**CR169 -Update of hydraulic tensioner tightening torque**  
**Panigale V4 (all model versions)**  
**Service Recall Campaign SRV-RCL-18-008**

Date: December 13, 2018  
 To: Dealer Principal, General Manager, Service Manager, North American Dealer Network  
 From: Richard Kenton, Technical Director  
 Matthew Feinstein, Regulatory Compliance Manager

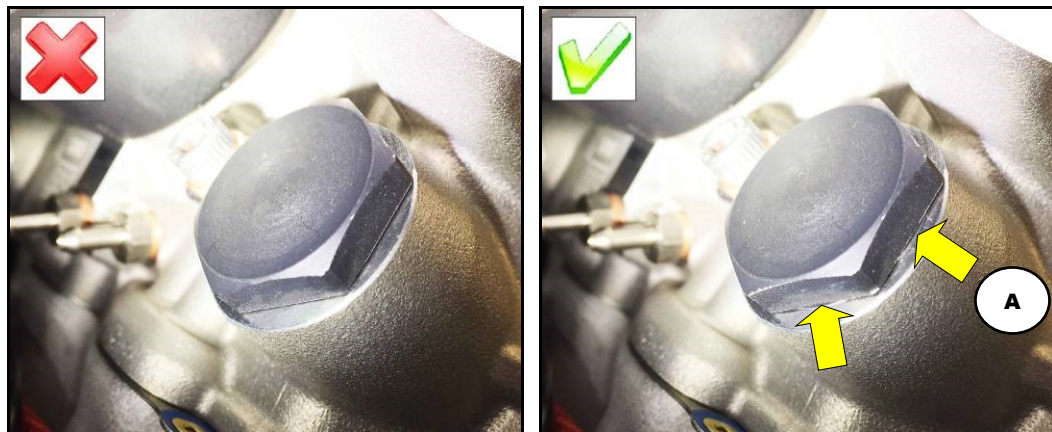
1. Position the bike on the rear paddock stand
2. Remove the battery cover and LH and RH side fairings (See Sec.5: "Fairing installation - Fairing" of the Workshop Manual)
3. Working on the left side of the motorbike, remove the left puller (See Sec.5: "Fairing installation - Fairing" of the Workshop Manual)
4. Thoroughly clean the area around the tensioners and perform a **visual inspection** of both tensioners to ensure **washer (A)** is installed on both tensioners

It is critical to perform the inspection without slackening the tensioner or removing the **washer (A)** as the washer is interference-fixed to the tensioner

- A. If **washer (A)** is not present, fill in a **YouTech** request attaching the detailed picture of the component and replace the hydraulic tensioner on a separate NORM warranty line repair
- B. If **washer (A)** is present, tighten the two hydraulic tensioners to the new tightening torque

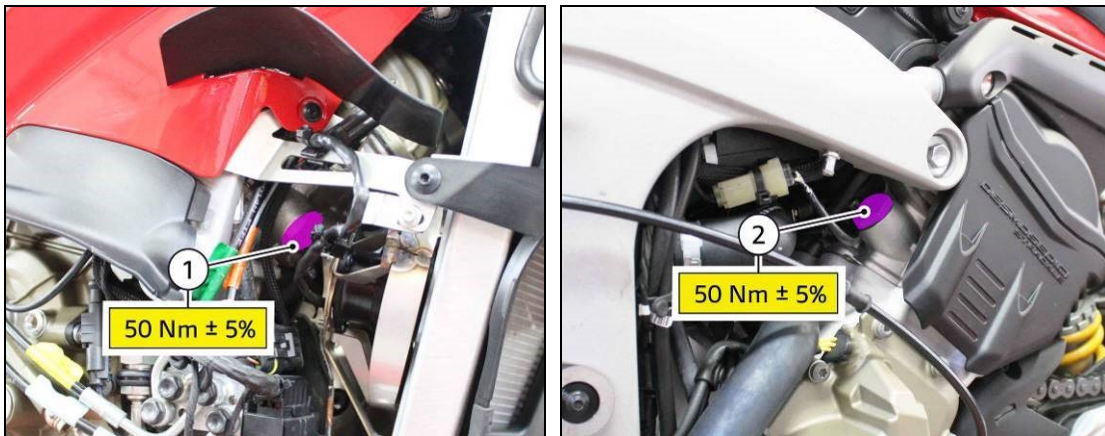
To prevent this issue we have increased the tightening torque of the two hydraulic chain tensioners. On all the above-mentioned vehicles it is necessary to update the tightening torque to **50 Nm ± 5%** (the previous tightening torque was 30 Nm ± 5%).

To tighten the two timing chain tensioners of the rear and front banks to the new specified torque use a torque wrench with 27mm polygonal socket (12pt box end)

5. Tighten timing belt **tensioner (1)** and **tensioner (2)** of front bank and rear bank to the new torque of **50 Nm  $\pm$  5%**
